Revision A This bulletin supersedes previous versions  
 Feb 2014 Added vehicles.

## TITLE: CAC TUBE SUPPORT IMPROVEMENT – FIX AS FAIL Prevost vehicles

On the vehicles affected by this bulletin, improvement of a Charge Air Cooler tube support is required. *This is a “Fix as Fail” bulletin, repair only the vehicles showing a cracked CAC tube.*

### CAC TUBE SUPPORT REPLACEMENT

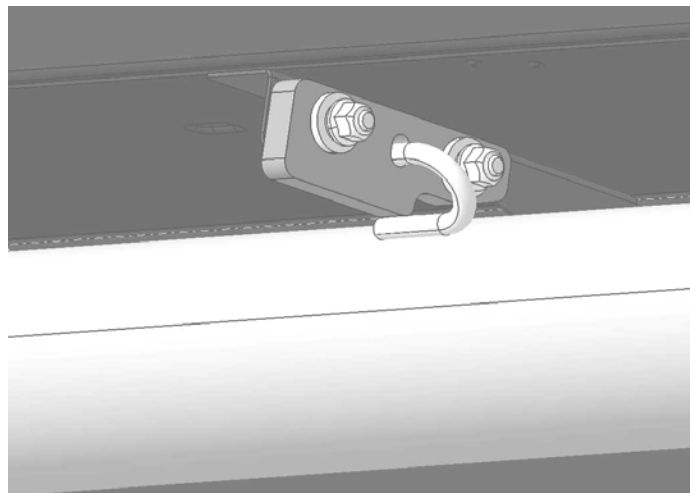
Locate this support along the top charge air cooler line in the engine compartment.

- 1) Remove the nuts and rubber damper. Discard parts.

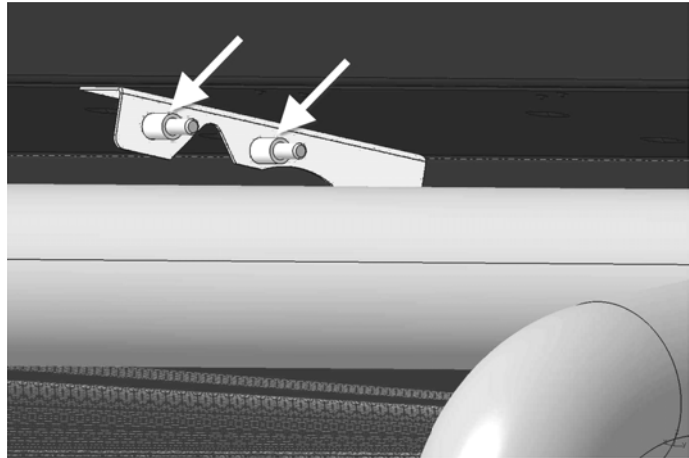
- 2) Remove the sleeves. Keep one sleeve for re-install.

Discard the other one.

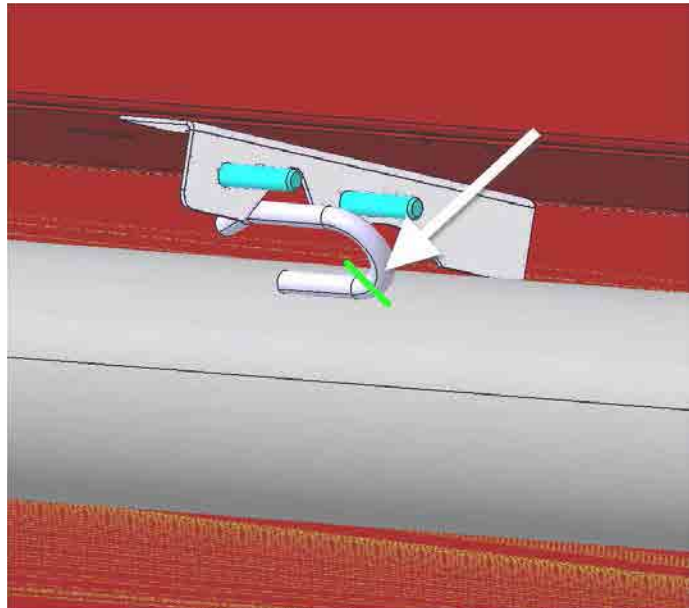
- 3) Cut the metal hook on the CAC tube. Cut at the location where solder ends.

Leave the remaining soldered rod on the tube.

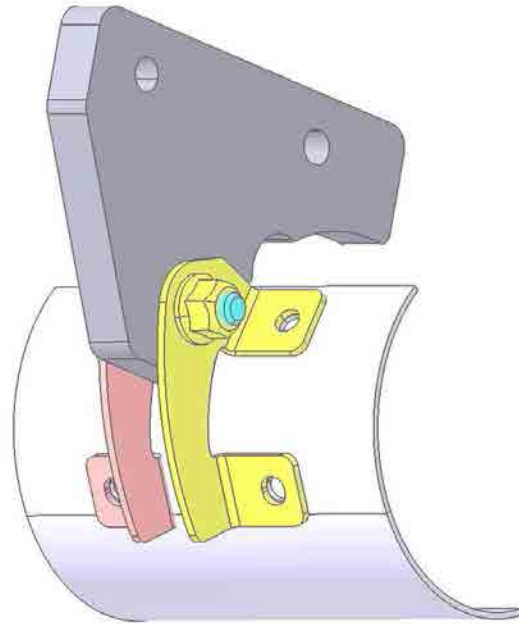
- 4) Insert small tube reserved earlier and insert in the new rubber support.

Assemble new rubber piece and support with bolt and nut. Coat threads with Anti-seize compound. Tighten to 16 lb-pi.

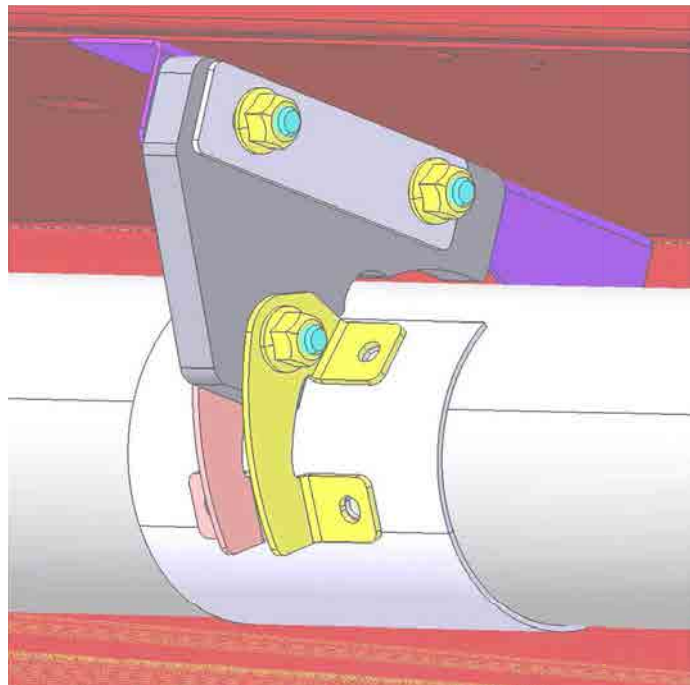
- 5) Install on vehicle. Place small plate as shown under flanged nuts. Use supplied flanged nuts for assembly.

Coat threads with anti-seize compound. Tighten to 16 lb-pi.

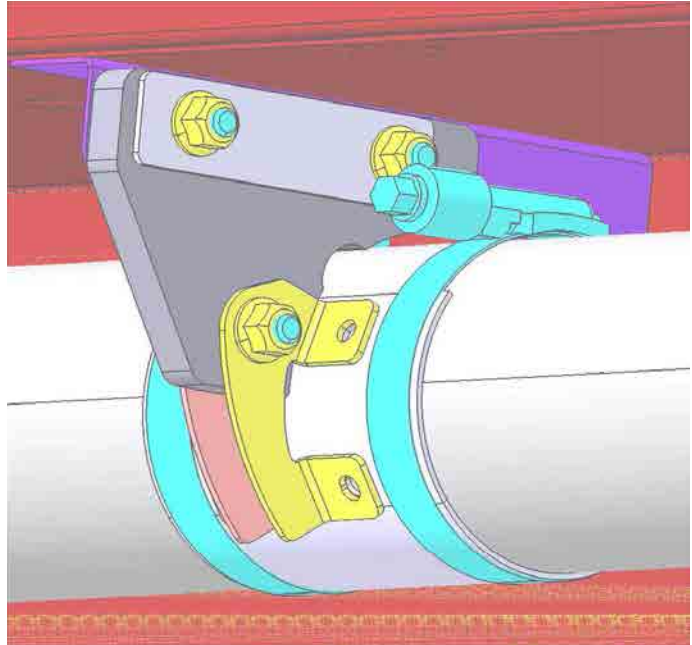
- 6) Install the two tube collars as shown. Collar drive screw should be horizontal to allow easy access.

Tighten collars to 8 lbs/pi
